**STAFF RECOMMENDATION**  
**1117 McKennie Avenue**  
**November 19, 2018**

**Application:** New Construction—Outbuilding/detached accessory dwelling unit (DADU); Setback Determination  
**District:** Lockeland Springs-East End Neighborhood Conservation Zoning Overlay  
**Council District:** 06  
**Map and Parcel Number:** 08301028400  
**Applicant:** Matt Millsap, Building Co. #7  
**Project Lead:** Paul Hoffman, paul.hoffman@nashville.gov

**Description of Project:** Application is for conversion of an existing one-story outbuilding to create a detached accessory dwelling unit (DADU). The existing outbuilding exceeds the footprint and setbacks permitted by the design guidelines and the DADU Ordinance.

**Boundary & Topographic Survey**  
 1117 Mckennie Avenue  
 Nashville, Davidson County, Tennessee, 37206

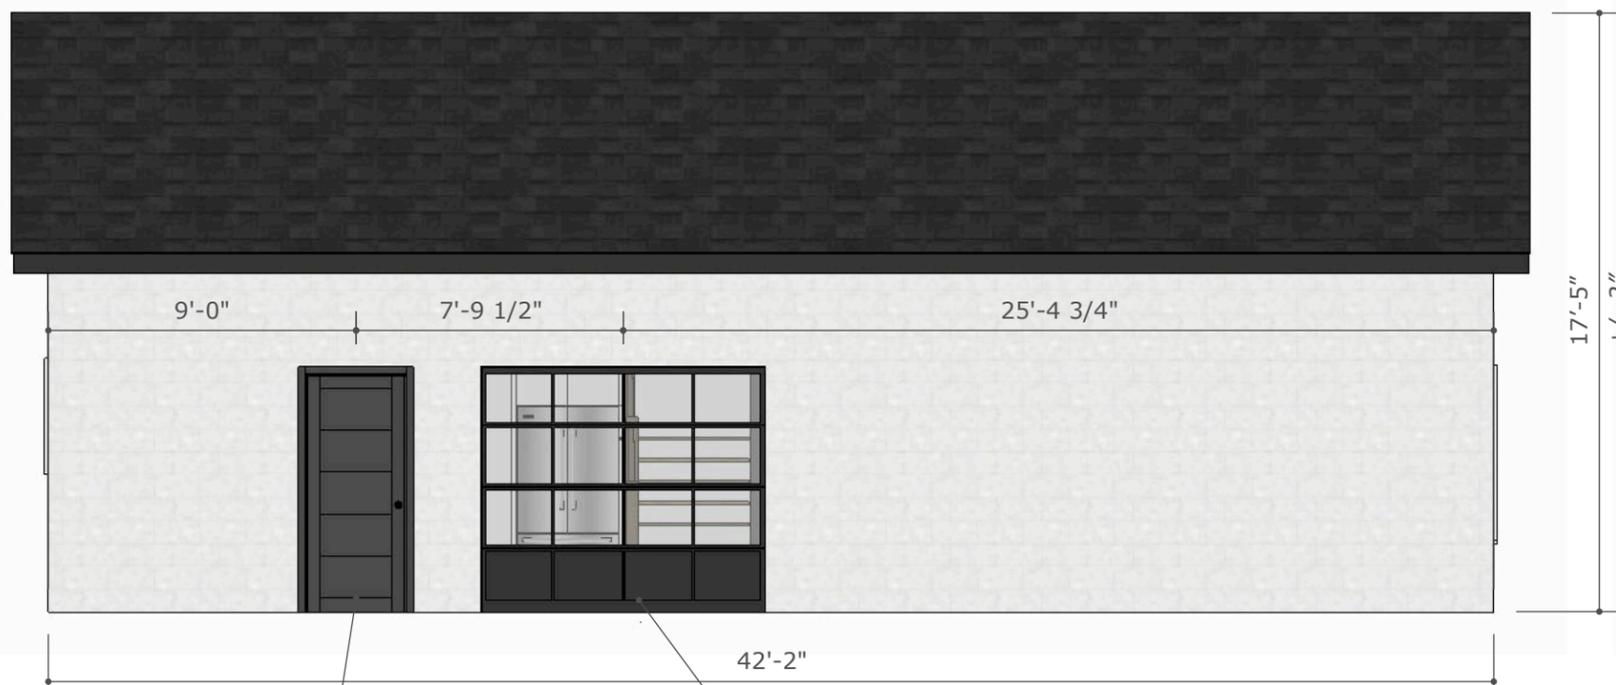
The existing outbuilding is located five feet (5') from the rear property line. The side setbacks are three feet (3') from the left side property line, and four feet, nine inches (4' 9") from the right side. The Commission has previously approved a

reduced side setback for an existing outbuilding. In that case there were no changes to the existing structure and the outbuilding was only one story and four hundred and twenty square feet (420 sq. ft.) with part of that square footage being an open porch. Because the size of the existing outbuilding exceeds the requirements for massing and two setback determinations would be needed; on one side of three feet (3') from the required five feet (5') and on the street-side approximately five feet (5') from the required ten feet (10'); staff does not find it to be appropriate to reduce the setback requirements. Staff finds that the proposal does not meet the requirements for setbacks. The project does not meet section II.B.h.2 of the design guidelines or 17.16.30.G. 4 of the ordinance.

SOUTH ELEVATION

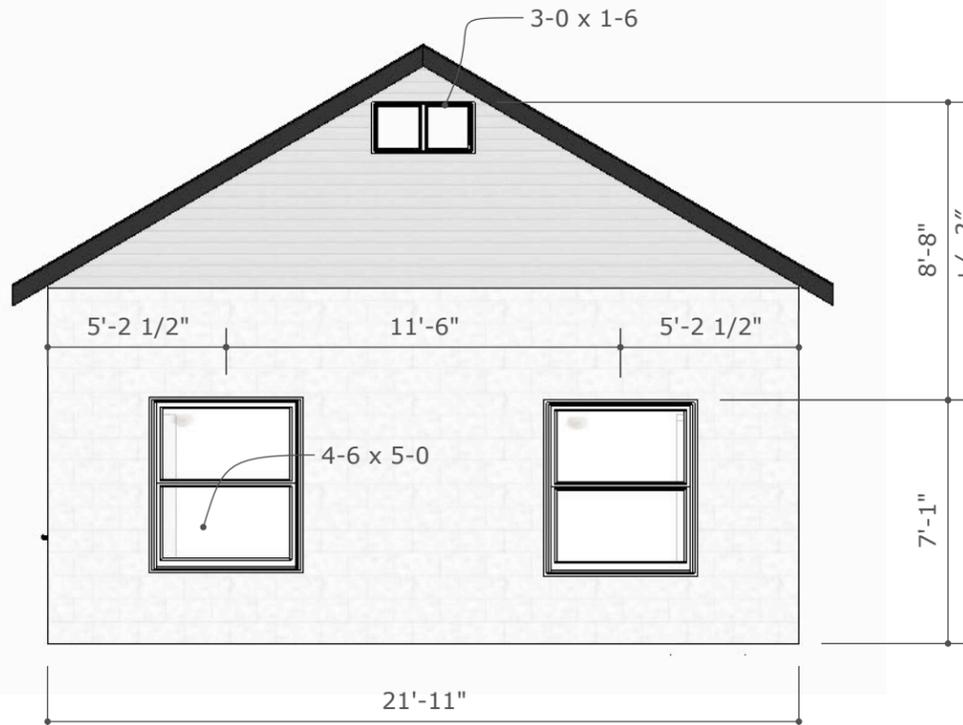
Materials: The doors and windows are proposed to be altered. Existing garage doors facing North Twelfth Street will be replaced with two windows. A new window will be added on the west side of the outbuilding. An existing garage door on the south side will remain. All materials are existing except for the new windows and doors.

(STREET SIDE) EAST ELEVATION

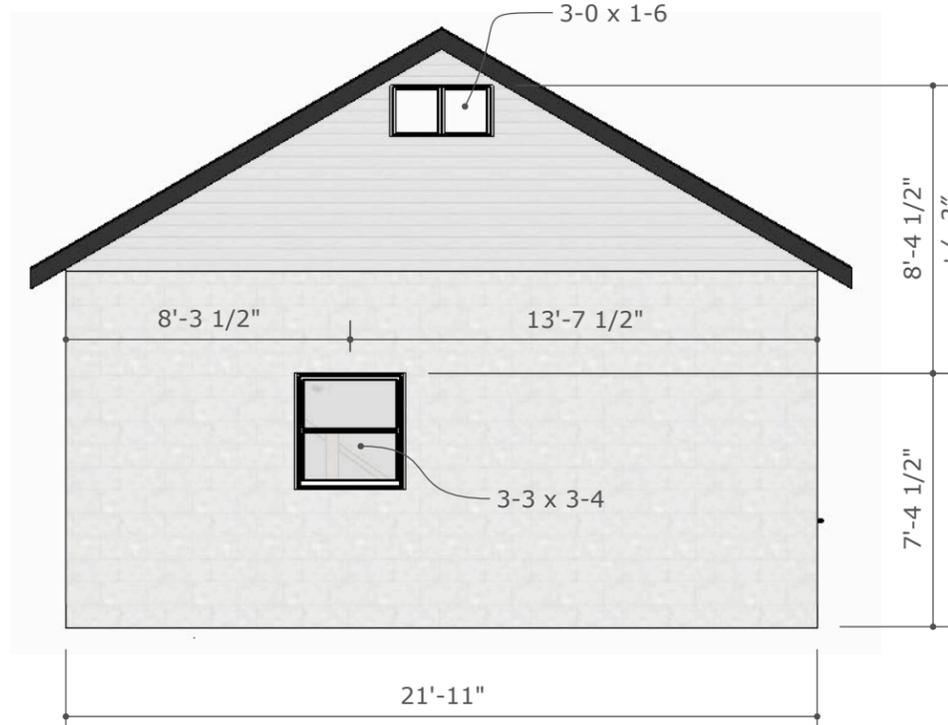
**Partial Demolition:** The two garage doors on the outbuilding’s east façade are proposed to be removed and replaced by windows. A window opening will be added on the opposite
